Project title
**Atlanta Road
 Site Plan**

PETITION NO: Z-25

PROPOSED USE: Townhomes

ZONING COMMENTS:

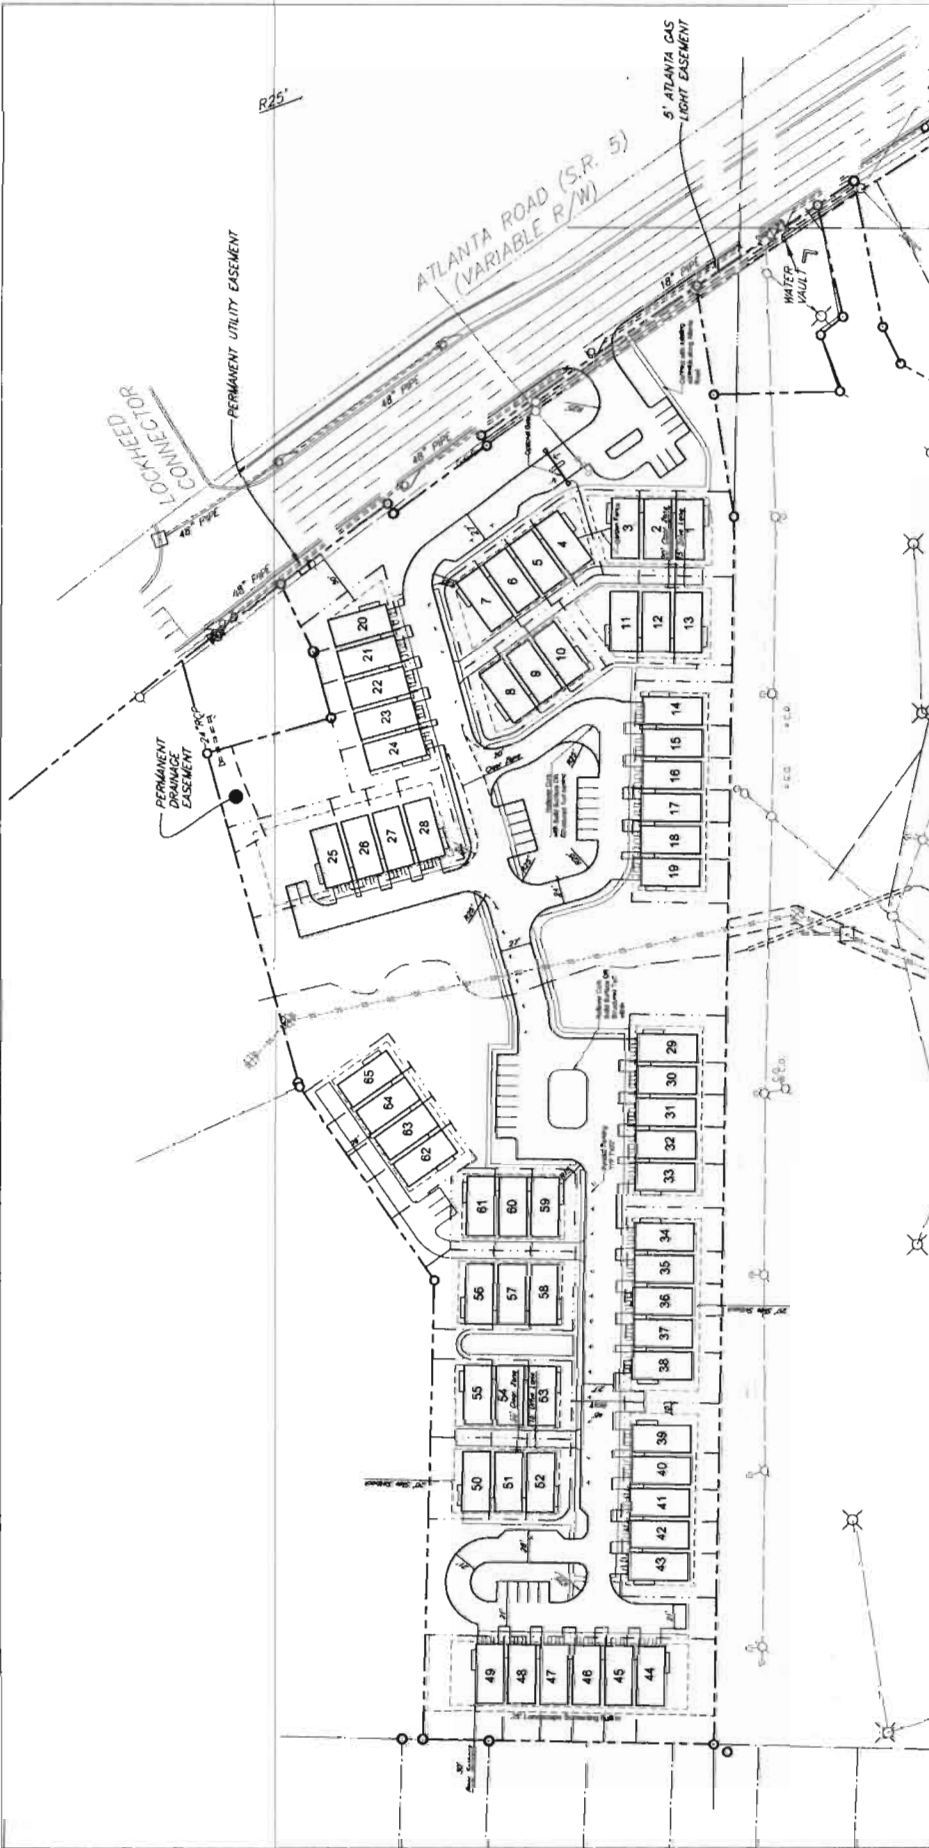
1. Waiving the rear setback for exterior lots from the required 35 feet to 30 feet along the western property line; and
2. Waiving the side setback for exterior lots from the required 40 feet to 20 feet on the north and south property lines.

Cobb County Zoning buffers must be fully vegetated across the full width of the buffer. The rear walls of the proposed units along the west property line are approximately 5 feet from the buffer. This may create safety, security, and maintenance issues for the occupants of those units. This will increase the likelihood of encroachments into this buffer. Cobb County staff will be obligated to regulate this buffer in perpetuity, including the mitigation of any buffer violations. Applicant should therefore consider reducing the footprint of the units adjacent to the buffer.

2. The existing stream channel that traverses the center of the site is indicated as a buffered stream on the County's stream buffer map. The required impervious setback will impact the location of units 19, 65 and 85. In addition, stormwater management for the development must also be located outside the undisturbed stream buffer. Unless this is placed underground, additional lots will be impacted by the need for a surface stormwater management facility.

Recommend entrance on Atlanta Road be at least 250' from the George Mcmillan Drive intersection. An entrance within 250' of a signalized intersection may be subject to turn restrictions. Recommend location and design be determined during plan review, subject to Cobb County DOT approval.
